The Commission has issued the enclosed Amendments Nos. 24 and 28 to Facility Operating Licenses Nos. DPR-24 and DPR-27 for the Point Beach Nuclear Plant, Units Nos. 1 and 2. The amendments consist of changes to the Technical Specifications and are in accordance with your application dated October 1, 1976.

These amendments consist of changes in the Technical Specifications that will modify the reactor coolant system pressure-temperature limits to account for neutron irradiation induced increases in reactor vessel metal nil ductility temperature (RTNDT), and will add a new specification showing the reactor vessel surveillance capsule withdrawal schedules.

POINT BEACH NUCLEAR PLANT, UNIT NO. 1

Amendment No. 24
License No. DPR-24

PBNP Unit No. 1 - Heatup Limitations
Applicable to 7 Effective Full Power
Years (Approx. June 1980)
Instrument Error is included.

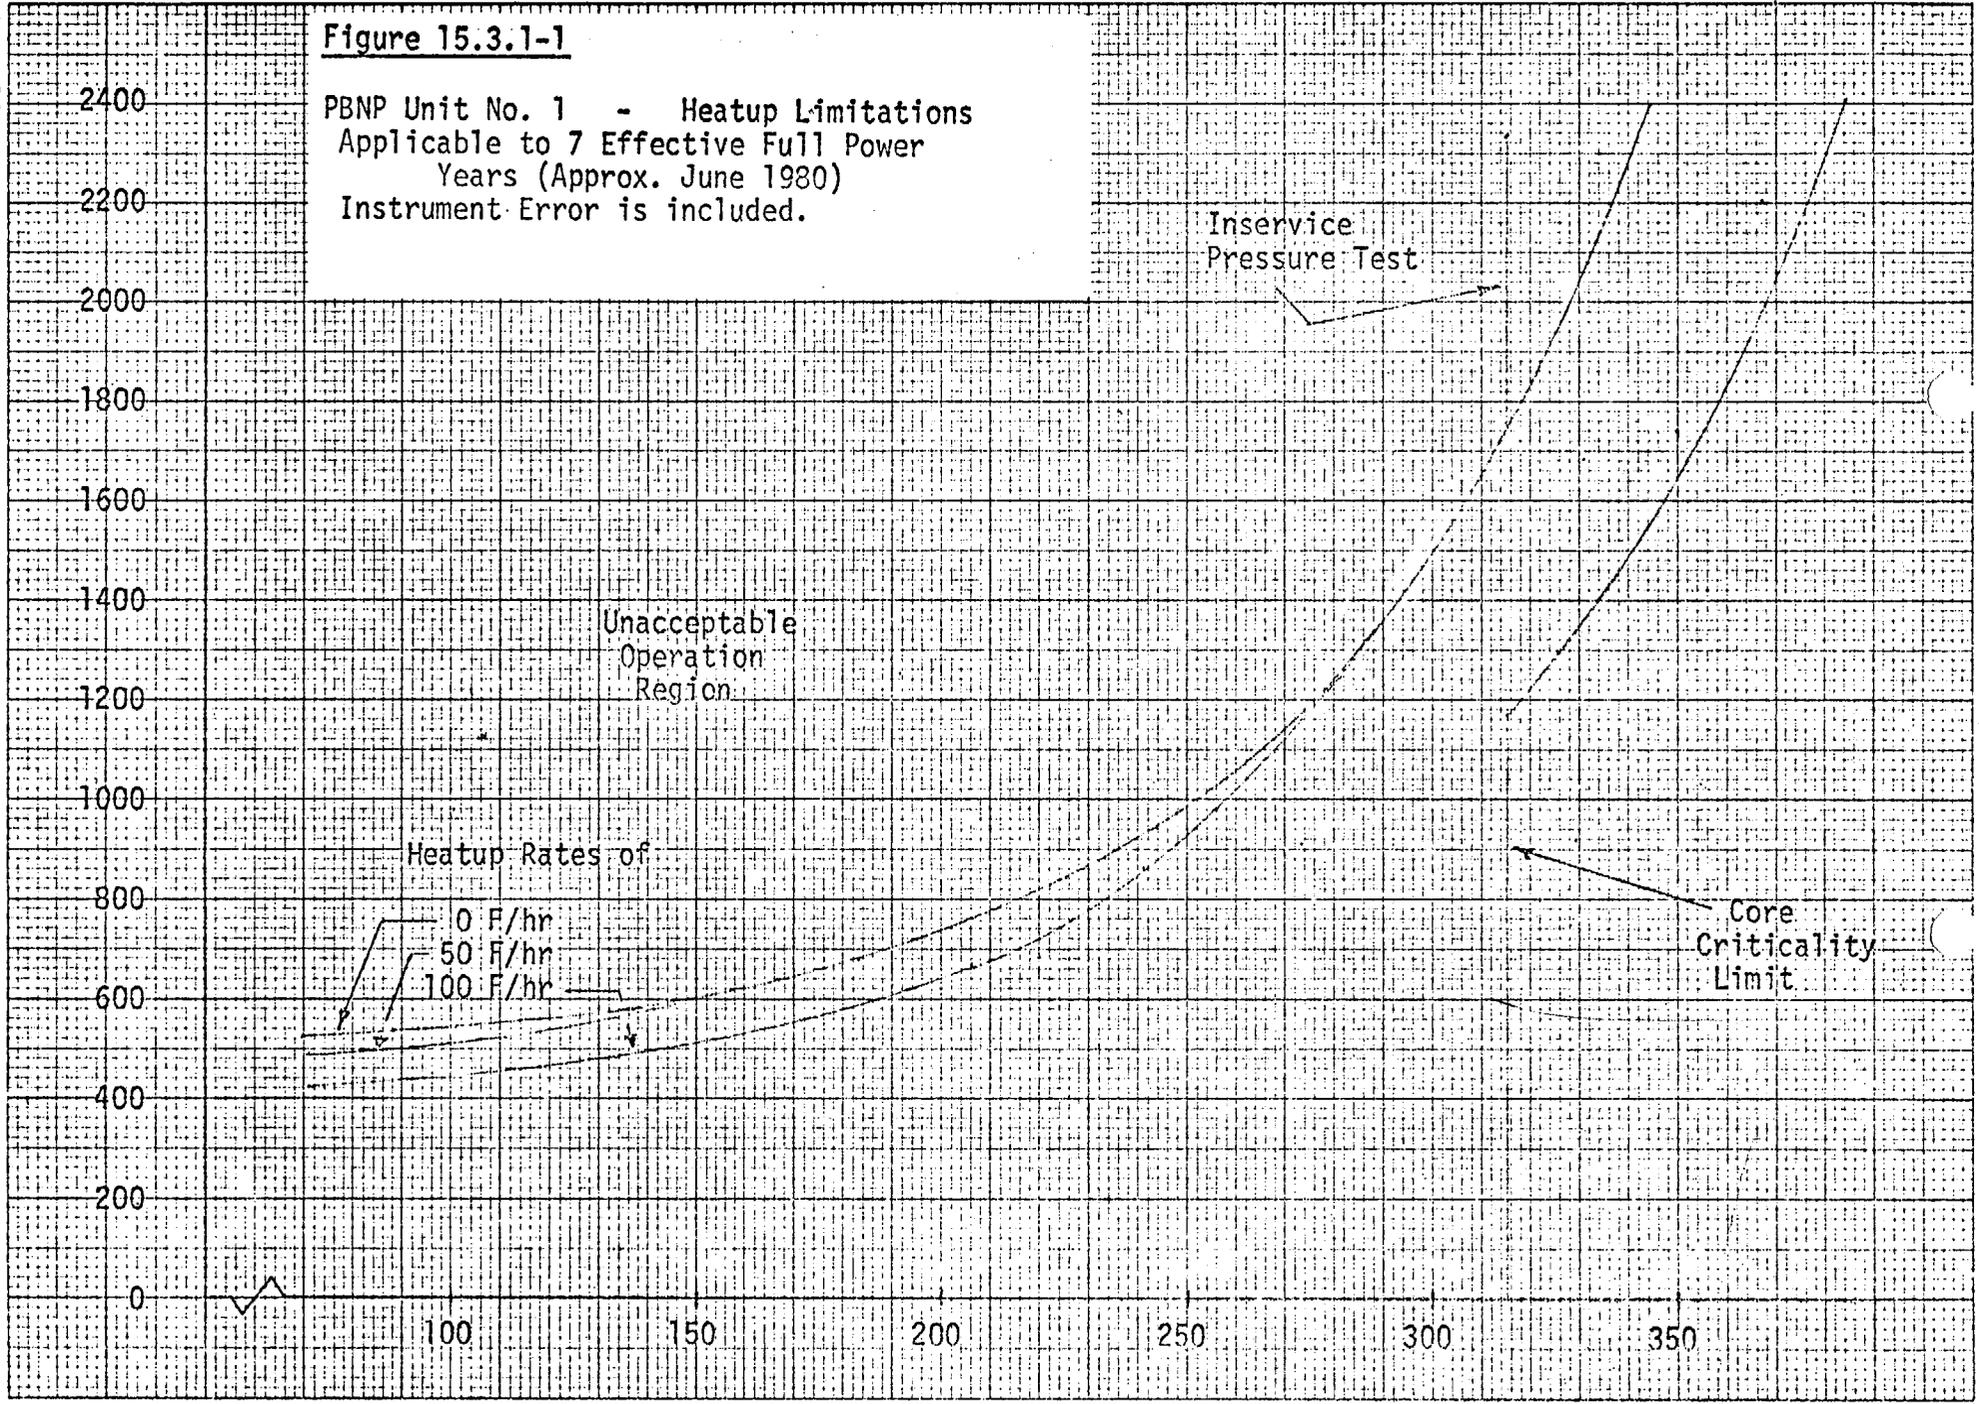
The attached Figures 15.3.1-1 thru 15.3.1-4 replace the existing

1. The Reactor Coolant System temperature and pressure shall be limited in accordance with the limit lines shown in Figure 15.3.1-1 and 15.3.1-2 (Unit 1) and 15.3.1-3 and 15.3.1-4 (Unit 2) during heatup, cooldown, criticality, and inservice leak and hydrostatic testing with:

The pressure-temperature limit lines shown on Figures 15.3.1-1 (Unit 1) and 15.3.1-3 (Unit 2) for reactor criticality and for inservice leak and hydrostatic testing have been provided to assure compliance with the minimum temperature requirements of Appendix G to 10 CFR 50 for reactor criticality and for inservice leak and hydrostatic testing.

PBNP Unit No. 1 - Heatup Limitations
Applicable to 7 Effective Full Power
Years (Approx. June 1980)
Instrument Error is included.

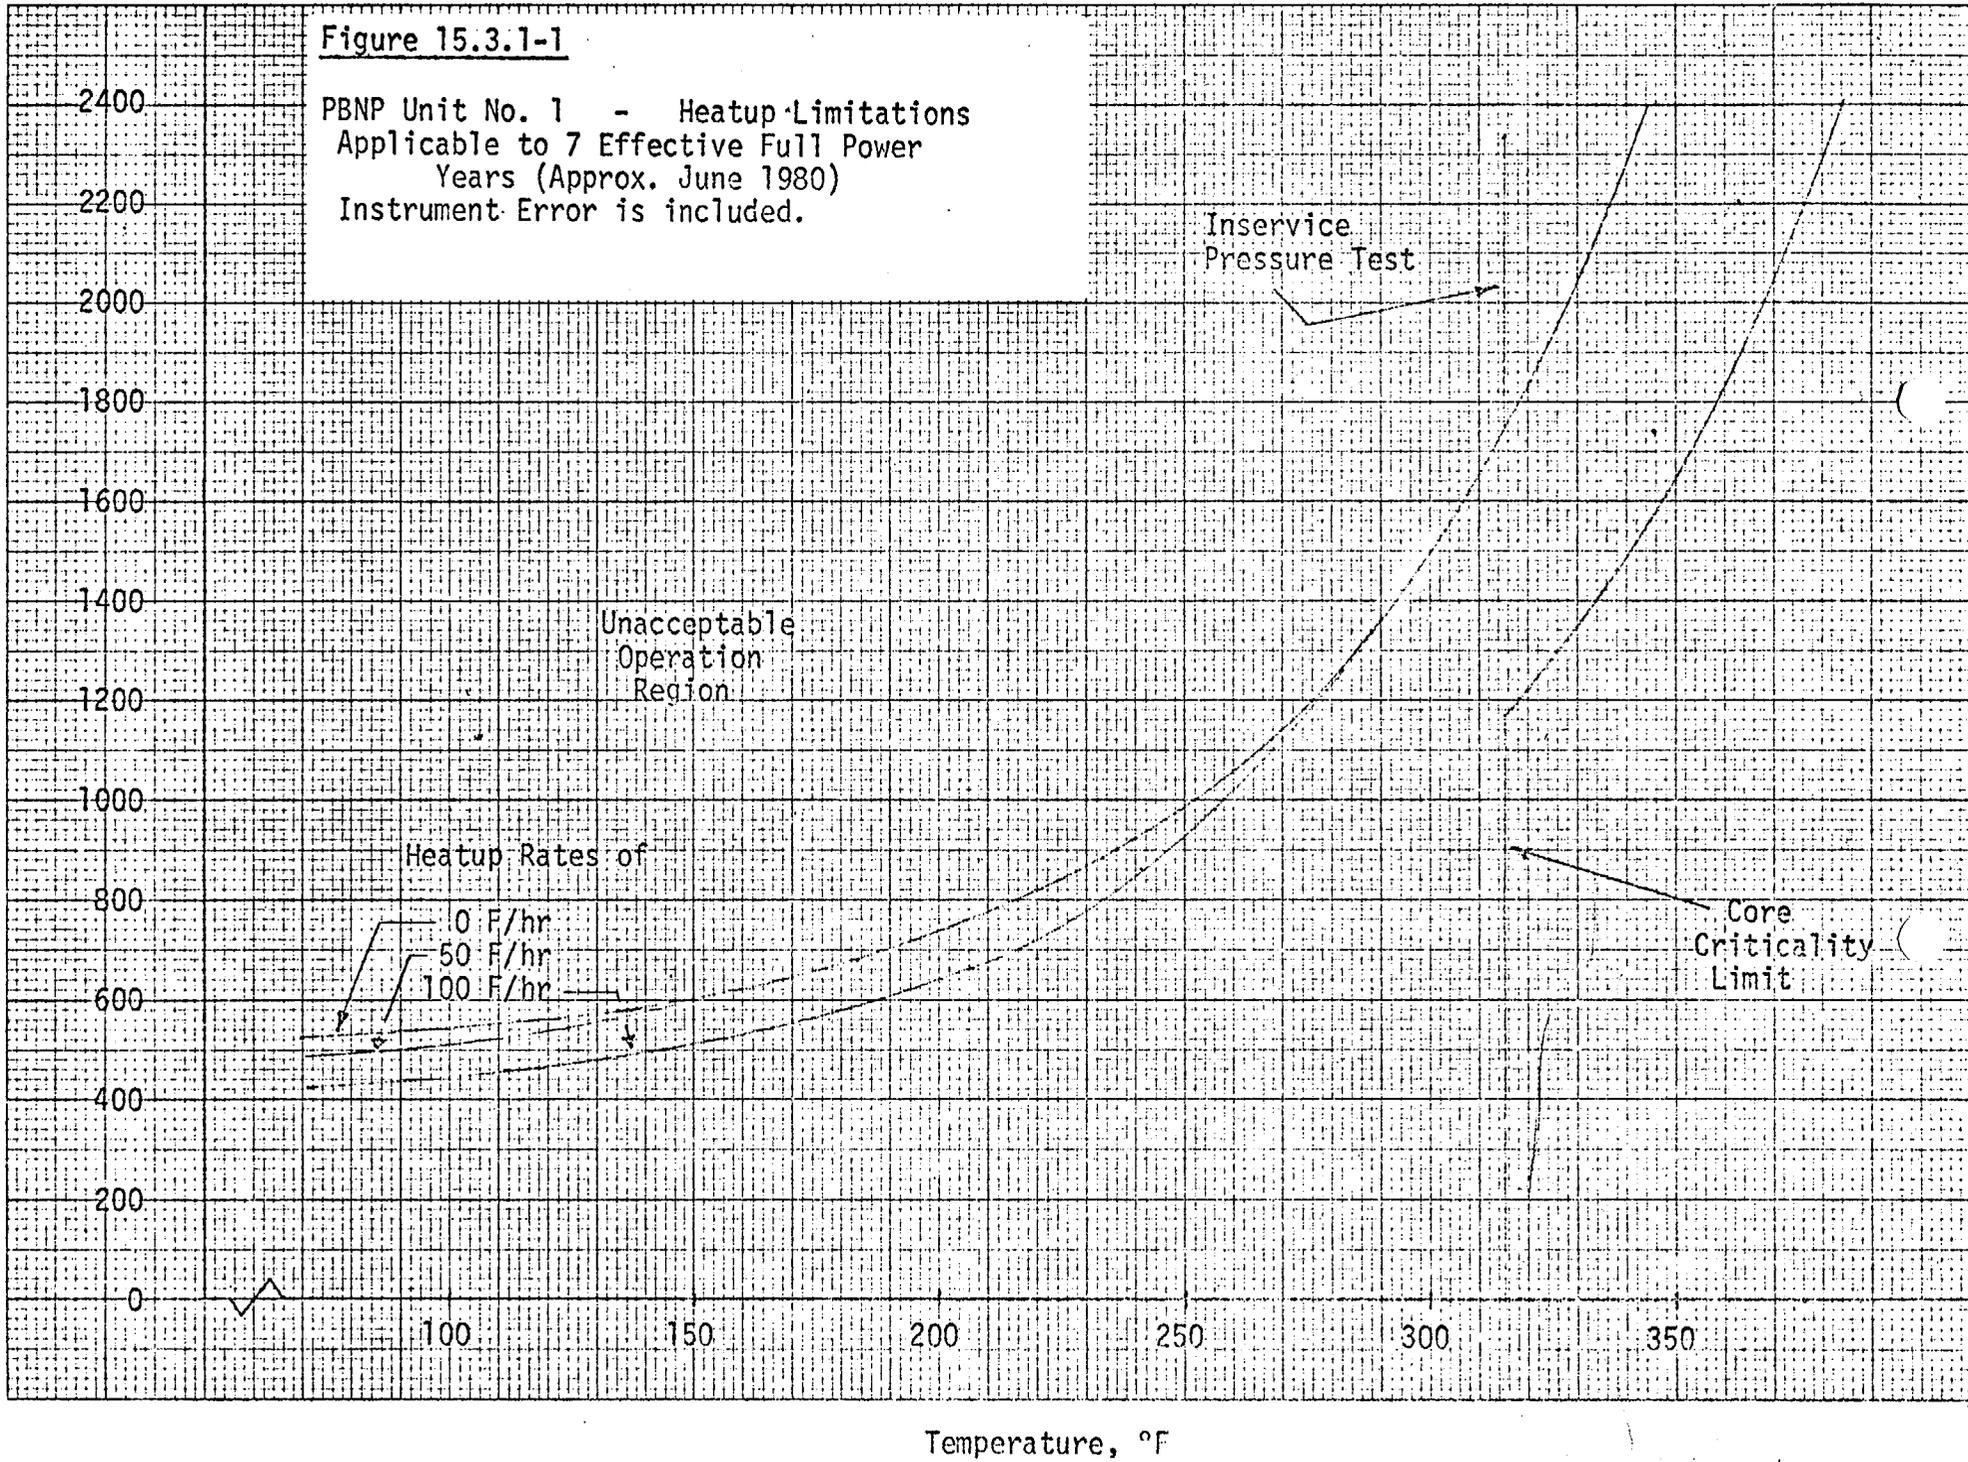
Replace pages 15.3.1-4 thru 15.3.1-8 with the attached revised pages (delete pages 15.3.1-4a and 15.3.1-4b). The attached Figures 15.3.1-1 thru 15.3.1-4 replace existing Figures 15.3.1-1, 15.3.1-1a, 15.3.1-2, 15.3.1-2a and 15.3.1-3. Add page 15.3.1-8a and Tables 15.3.1-1 and 15.3.1-2.

1. The Reactor Coolant System temperature and pressure shall be limited in accordance with the limit lines shown in Figure 15.3.1-1 and 15.3.1-2 (Unit 1) and 15.3.1-3 and 15.3.1-4 (Unit 2) during heatup, cooldown, criticality, and inservice leak and hydrostatic testing with:

The heatup and cooldown curves presented in Figures 15.3.1-1 and 15.3.1-2 (Unit 1) and 15.3.1-3 and 15.3.1-4 (Unit 2) were calculated based on the above information and the methods of ASME Code Section III (1974 Edition) Appendix G, "Protection Against Nonductile Failure" and are applicable up to the operational exposure indicated on the figures. Corrections for possible instrumentation inaccuracies have been incorporated into these curves. The temperature correction is made by adding the temperature error (10F°) to the required temperature and the pressure correction is made by subtracting the pressure error (30 psi) from the required pressure. These corrections adjust the curves in the conservative direction.

The pressure-temperature limit lines shown on Figures 15.3.1-1 (Unit 1) and 15.3.1-3 (Unit 2) for reactor criticality and for inservice leak and hydrostatic testing have been provided to assure compliance with the minimum temperature requirements of Appendix G to 10 CFR 50 for reactor criticality and for inservice leak and hydrostatic testing.
